NORTHEAST UTILITIES

Millstone Nuclear Power Station, Unit No. 3
Technical Specifications - Proof and Review

TECHNICAL SPECIFICATIONS ADDITIONAL REVIEW AND
INFORMATION ITEMS

FIGURE 3.4-4a
NOMINAL MAXIMUM ALLOWABLE PORV
SETPOINT FOR THE COLD OVERPRESSURE SYSTEM
(FOUR LOOP OPERATION)

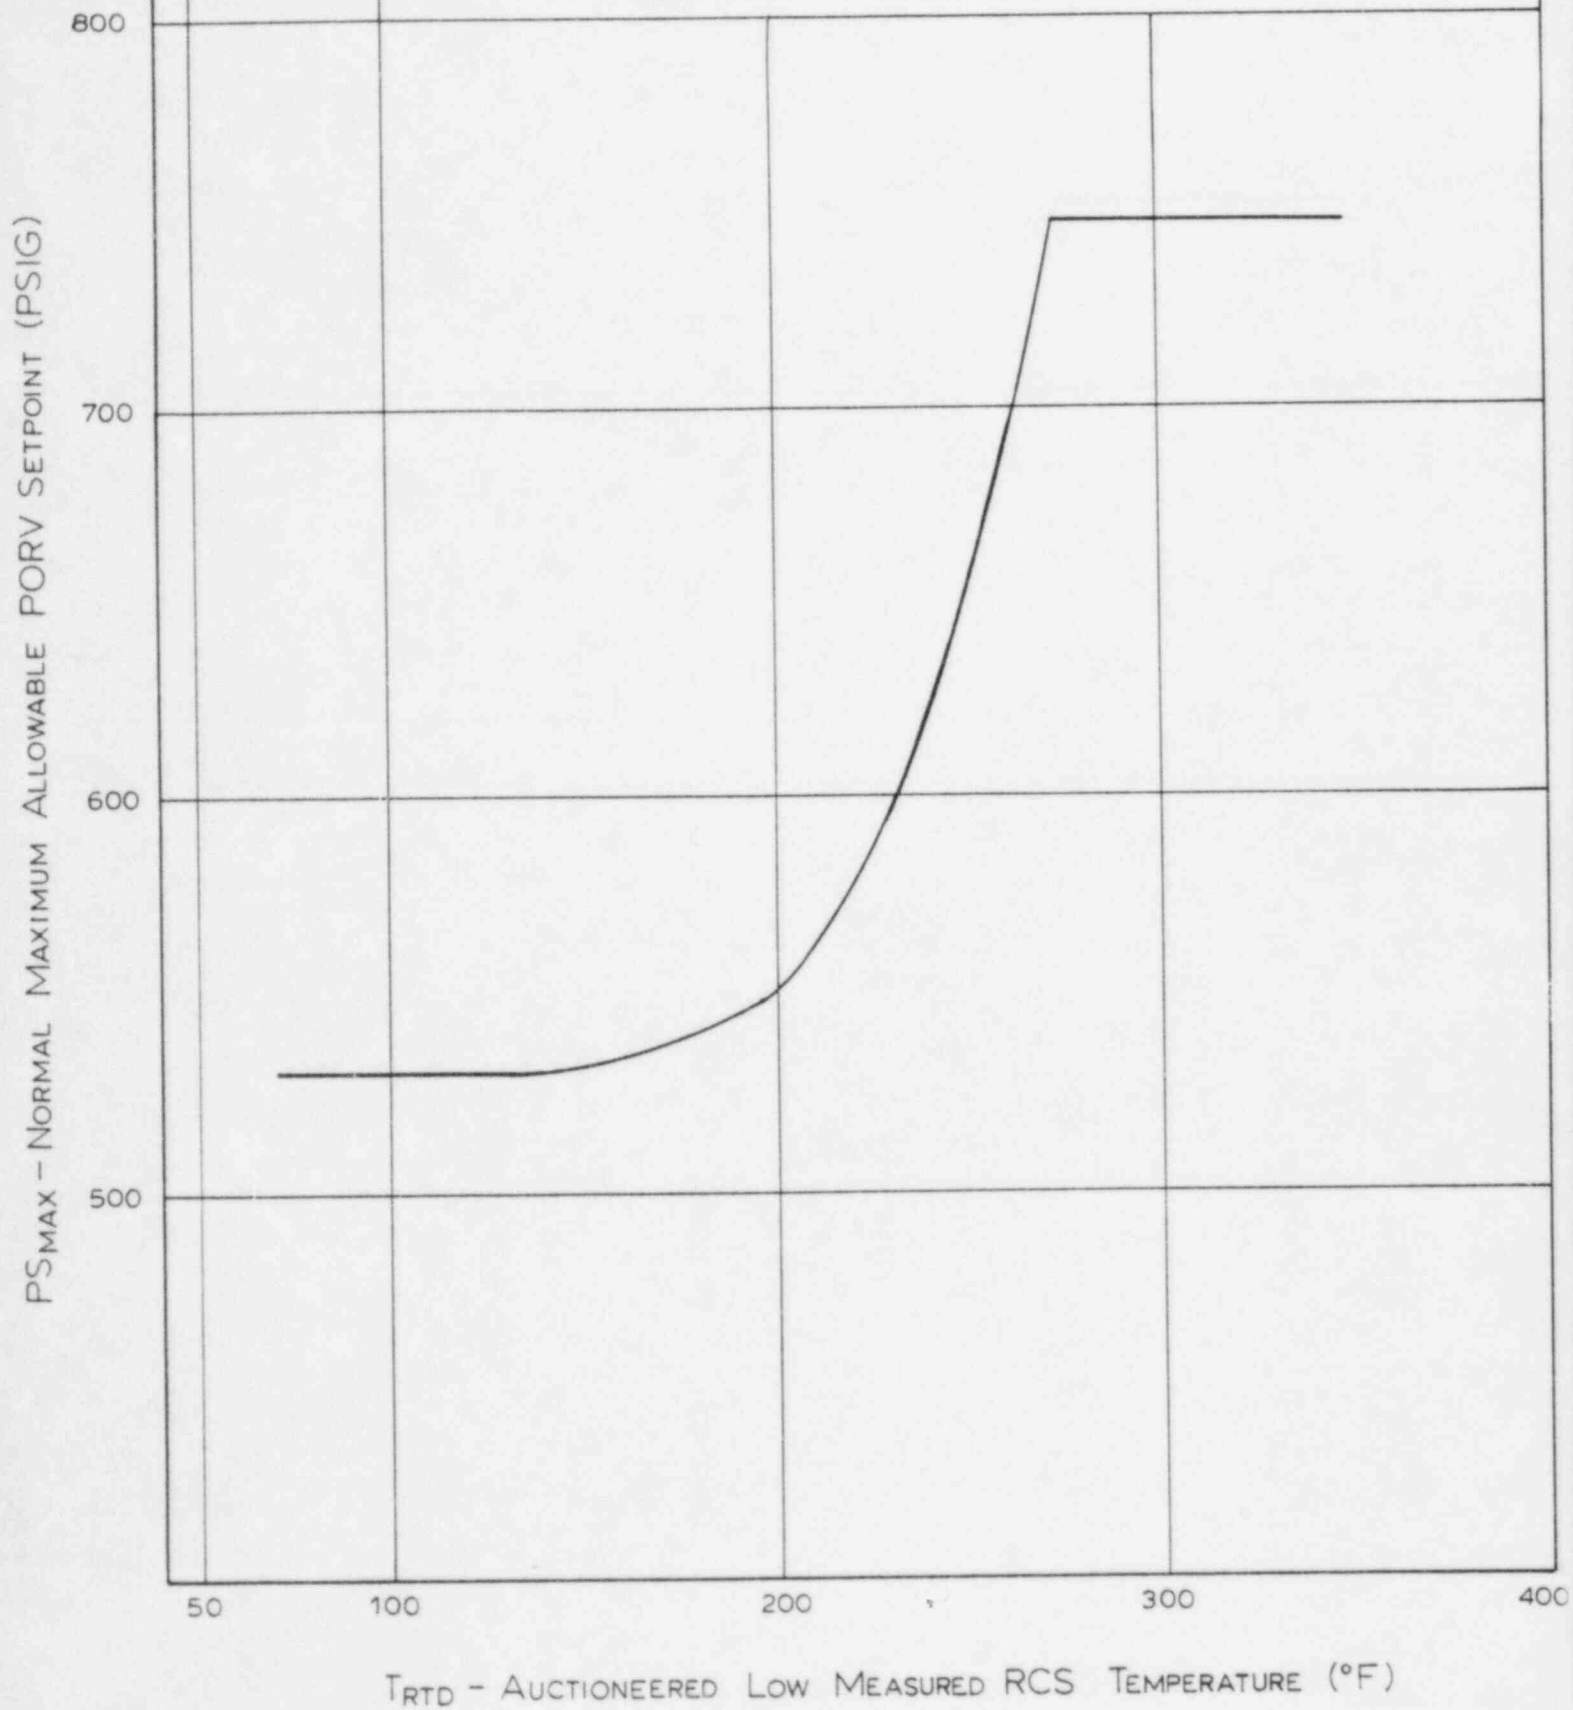
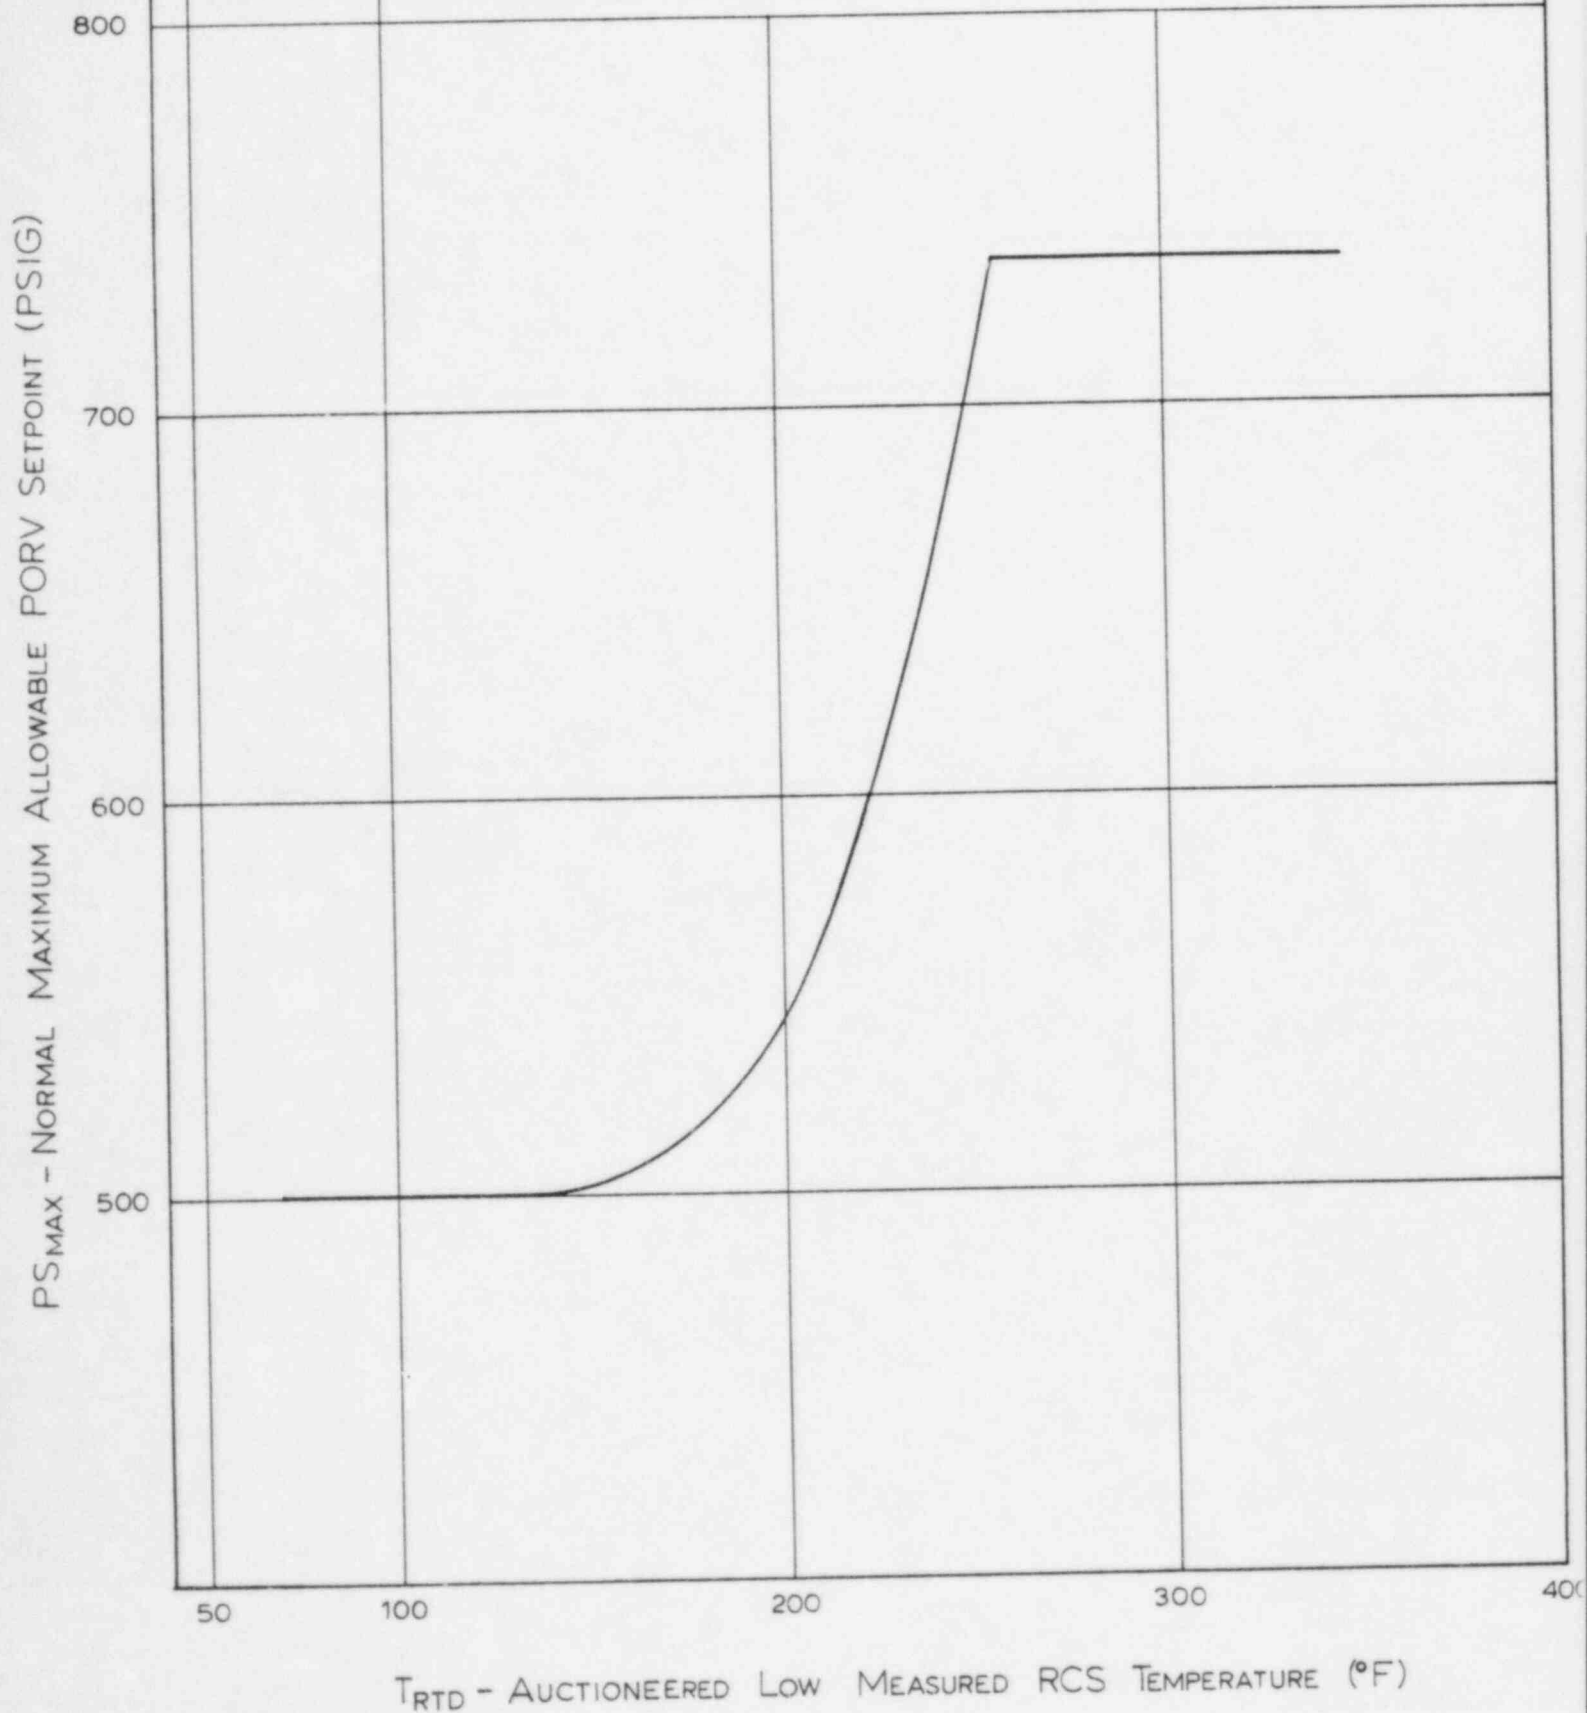
As described in FSAR sections 5.2.2 and 5.2.2.11, and SER (NUREG 1031) section 5.2.2.2, the reactor coolant system (RCS) is protected by pressurizer power operated relief valves (PORV's) and residual heat removal (RHR) reliefs at low temperature operation. The PORV's regulate RCS pressure by responding to open and close signals provided by a manually initiated automatic control system. This control system regulates RCS pressure within limits shown on technical specification Figure 3.4.-4a & b. Because of this range of control, specific to the Millstone 3 design, it is inappropriate to reference a maximum PORV setpoint pressure in technical specifications. NNECO requests the NRC reconsider its original technical specification proposal with respect to the PORV's.

When the RHR system is in operation during low temperature water solid RCS conditions, the RHR liquid relief valves also provide overpressure protection by design. Credit for this means of RCS pressure control should be acknowledged in MP-3 technical specification as originally presented in our December 7, 1984 submittal.

The RHR relief valves, which help to protect the RCS against overpressurization at low temperature operation, have a setpoint of 450 psig (per SER section 5.2.2.2 and FSAR section 5.4.7.2.4.
